RE: Addendum to Final Drainage Report – River Bend

RIVER BEND DEVELOPMENT	CAD NO 8842BASE	JOB NO 884-2
GRADING, STORMWATER, AND DRAINAGE PLAN	DATE 04/08/24

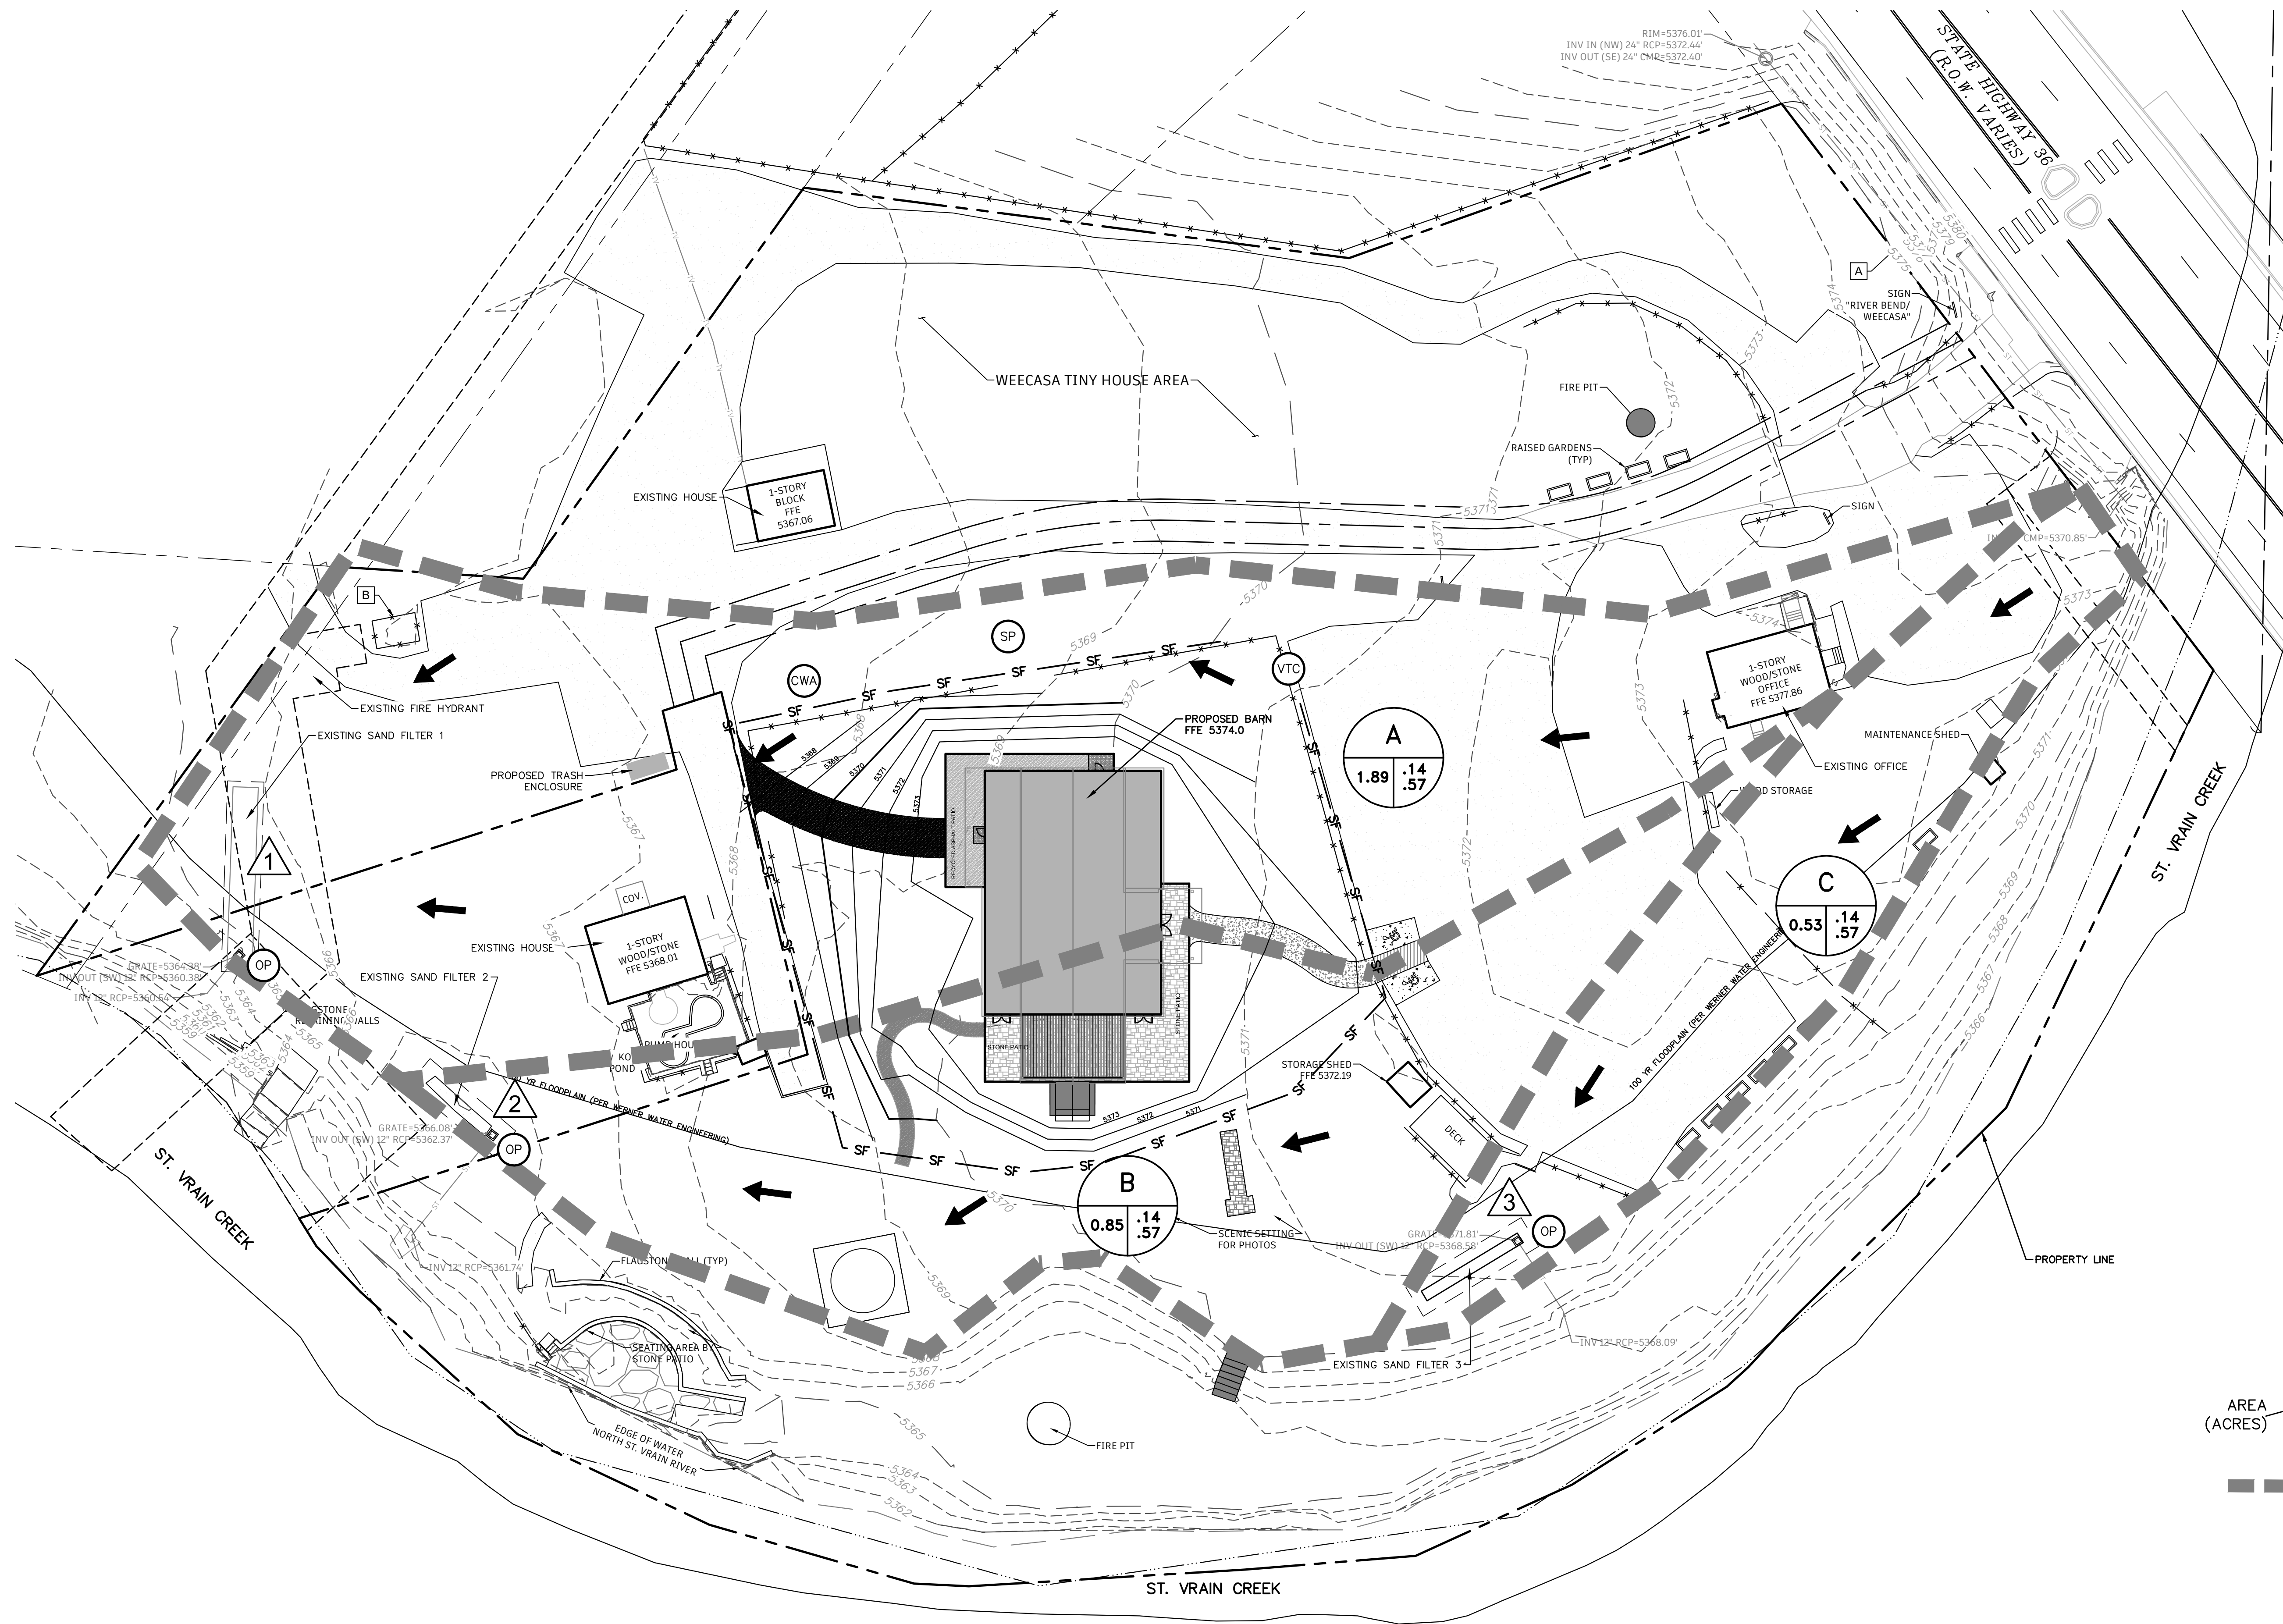
Calculations were completed (on the next page) to compare the impervious areas of the 2022 report and the plan being proposed today and it was found that the assumptions in the report were very conservative. The result is that about 9000 SF of grass area is being proposed in the current design versus was calculated 2 years ago. The result is that the sand filters that were built are oversized for what is being proposed today and do not need to be modified.

To remove

5456 \square prop Barn

9765 \square grass
added
↑
